15.5.U.1 Chassis Support bars

Replace 15.5.V with the following

Diagram 16.12.1
By Tom Devitt

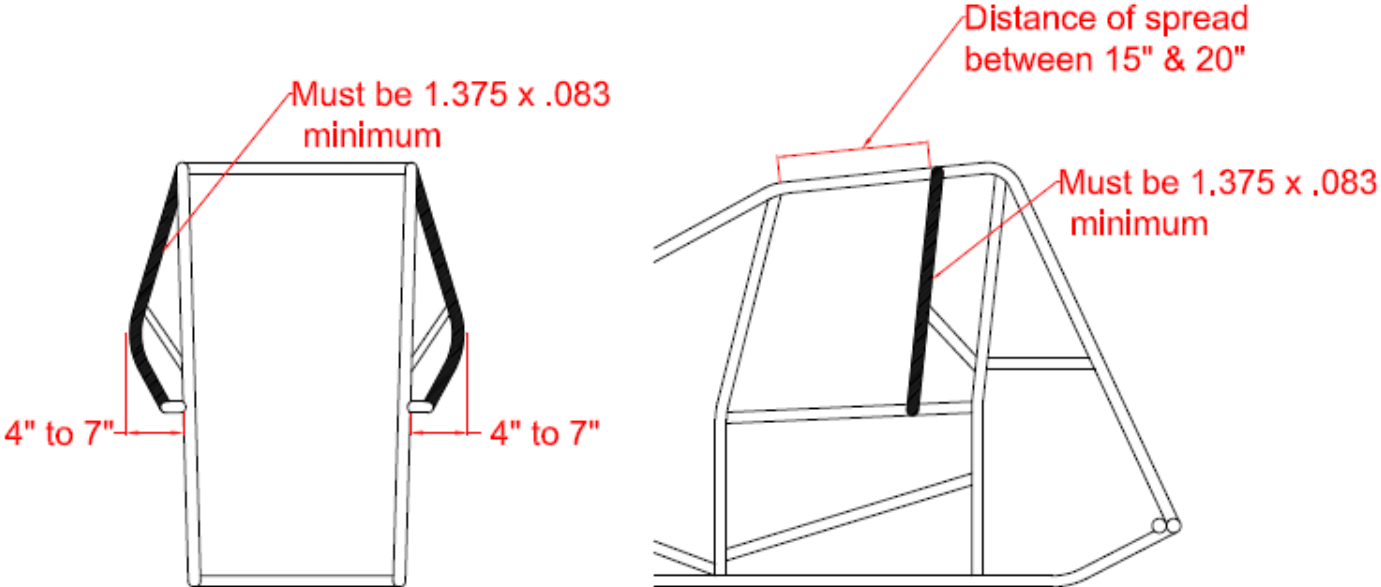
1. Support bar may be designed similar to what was known as a "safety bar". It must be attached to the top rail at a point 15" to 20" from the rear of the front upright. It must attach to the hip rail and have a gusset attached to the rear upright near a point opposite of the rear brace/shock mount bar. The curve must be between 4" and 7" measured from outside of the rear upright tube to the outside of the support bar. See Diagram #16.12.1

Diagram 16.12.2
by Tom Devitt

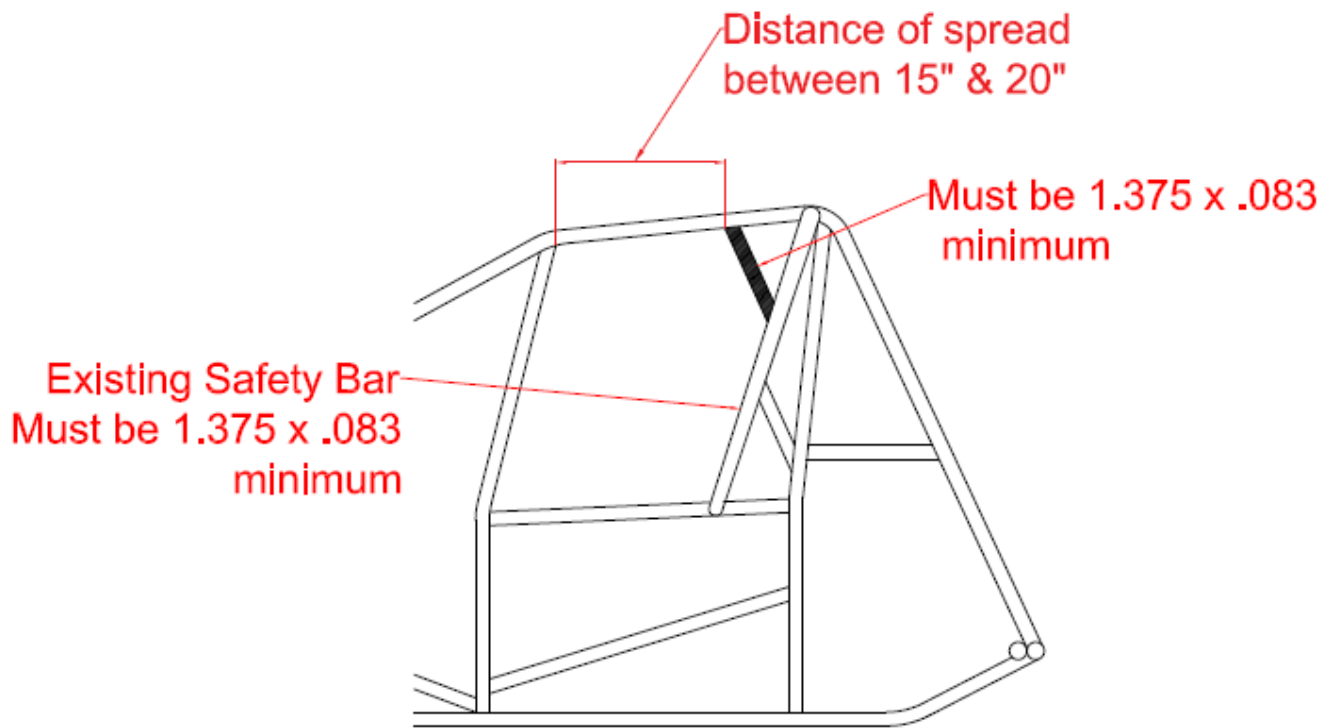
2. Existing chassis with a left side support bar installed (formerly called safety bar) that do not meet the option one specification above, may add a gusset that attaches to the top rail 15" to 20" from the rear of the front upright and angle to the support bar. The existing support bar tubing must meet the minimum as described above (1.375 X .083 ASTM4130 normalized steel or equivalent material). See Diagram #16.12.2

Drawing 16.12.3
By Tom Devitt

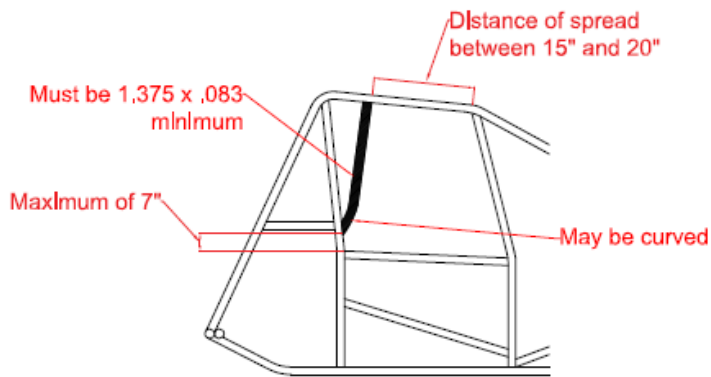
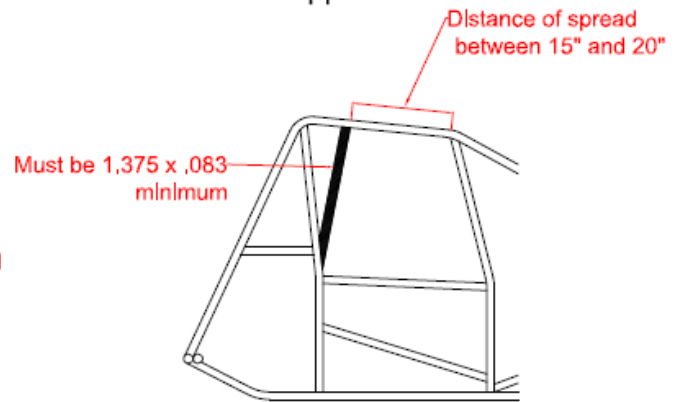
3. A support bar may be added to the top rail at a point 15" to 20" from the rear of the front upright and to the rear upright near a point of the rear brace / shock mount bar but no higher than 7" above the hip rail. This bar may have a slight curve near the rear upright to accommodate elbow room and ease of fitment. See diagram #16.12.3

Drawing 16.13.1
by Tom Devitt

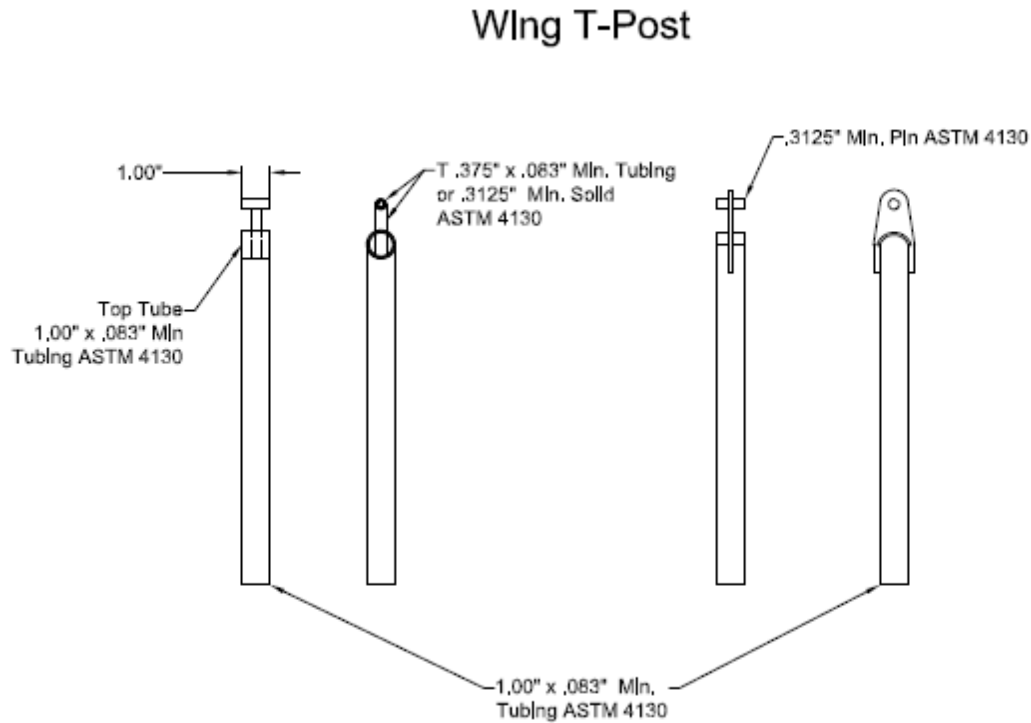
Wing T-Post will be built from 1" X .083" minimum ASTM4130 normalized steel or equivalent material. Wing attachment designs will be subject to approval. The only cast pieces approved will be HRP Part #HRP8811-A75-HD. If new T-Post designs are developed they must be submitted for approval. Some approved T-Post designs are in the drawings section 16. See Drawing #16.13.1
